UNITED STATES PATENT AND TRADEMARK OFFICE

APPLICATION NO.	FILING DATE	FIRST NAMED INVENTOR	ATTORNEY DOCKET NO.	CONFIRMATION NO.
10/764,160	01/23/2004	Robert C. Lyne JR.	P1035.lyne	8161

Office Action Summary	Application No. 10/764,160	Applicant(s) LYNE, ROBERT C.	
	Examiner Marc Jimenez	Art Unit 3726

DETAILED ACTION

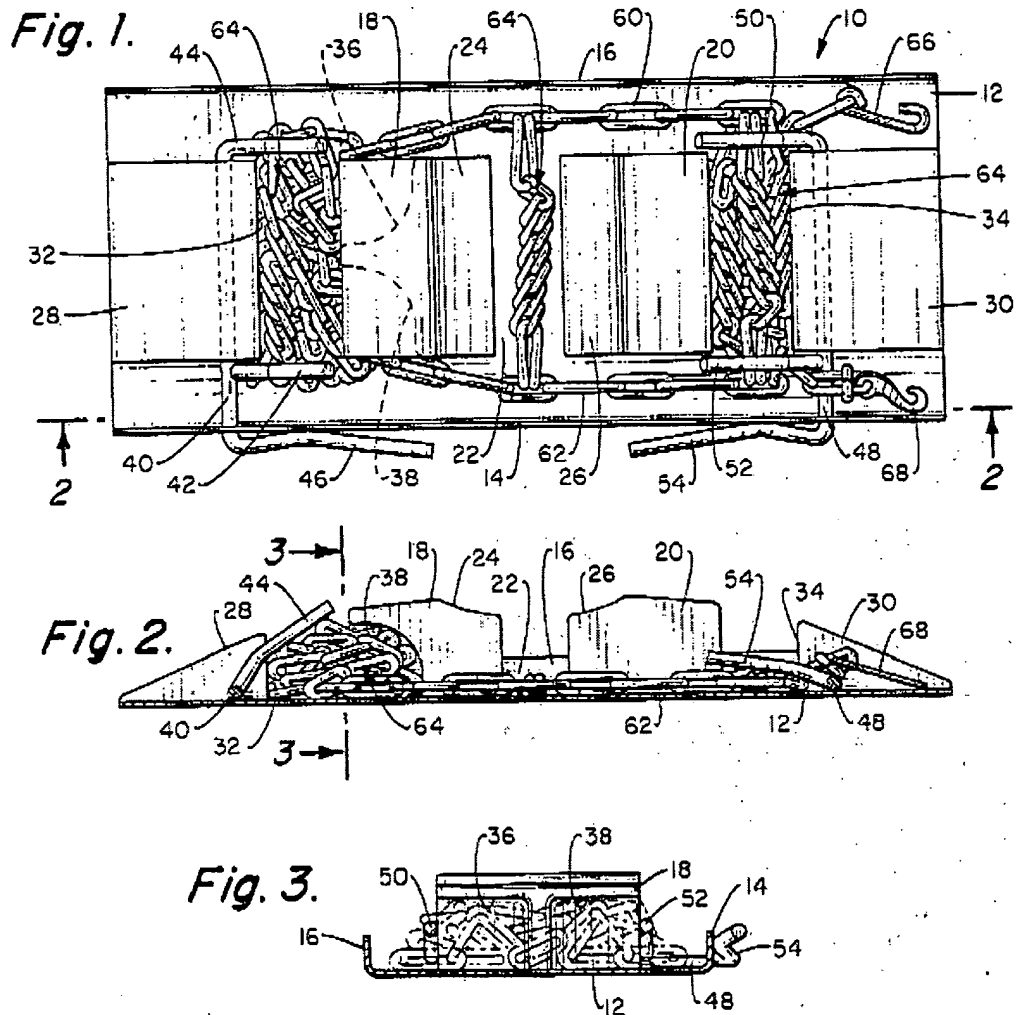
4. **Claims 1, 2, 8, 9, and 22** are rejected under 35 U.S.C. 102(b) as being anticipated by Planz (US 3,893,500).

Planz teaches a base **12** having a longitudinal axis and, at opposite ends of the axis, a rear end **28** and a front end **30**, an exterior rear wall **28** and exterior side walls **14,16** projecting upwardly from the base **12**, a plurality of vehicle supports **24,26** projecting upwardly from the base **12** and being spaced from each other and from the side walls **14,16** so as to define longitudinal channels and transverse channels for receiving and confining laid-out side chains **62** and cross chains **64**, respectively, a well **64** for receiving side chains and cross chains which have not been laid out **38**, an interior wall projecting upwardly from the base defining, an upwardly facing compartment adjacent the well **64** for receiving the U-shaped tool and protecting from damage due to the weight of the vehicle, which compartment has a bottom defined by the base and a side defined by the interior wall, the interior wall being located between the well **64** and the compartment (the compartment is where the tool **44** is located, the compartment clearly has an “interior wall”), so as to keep the chain which has not been laid out contained in the well and thereby prevent it from coming into the compartment during storage or handling of the tray. It is noted that the compartment **64** could also be considered a “well” and the tool **54** could be considered a “U-shaped tool”. See also a copy of figures 1-3 of Planz below with each of the features labeled corresponding to the claimed invention.

Regarding claims 2-3, the wall defining the compartment where tool 44 or 54 is located is sufficiently high and is defined by a plurality of walls.

Regarding claim 4, the well 64 is defined by the rear wall and portions of the side walls 16, 14.

Regarding claim 7, the side walls **14,16** have a relatively greater height defining the well **64** and a relatively lesser height near the supports **24,26**. The side walls are relatively greater in height compared to the well and a relatively lesser height compared to the supports.

Regarding claim 8, the interior wall **32** separates the well **64** from a substantial portion of the compartment.

Regarding claim 9, since there are two tools **44,54**, one could be considered a “U-shaped tool” and the other could be considered “a chain element holder”.
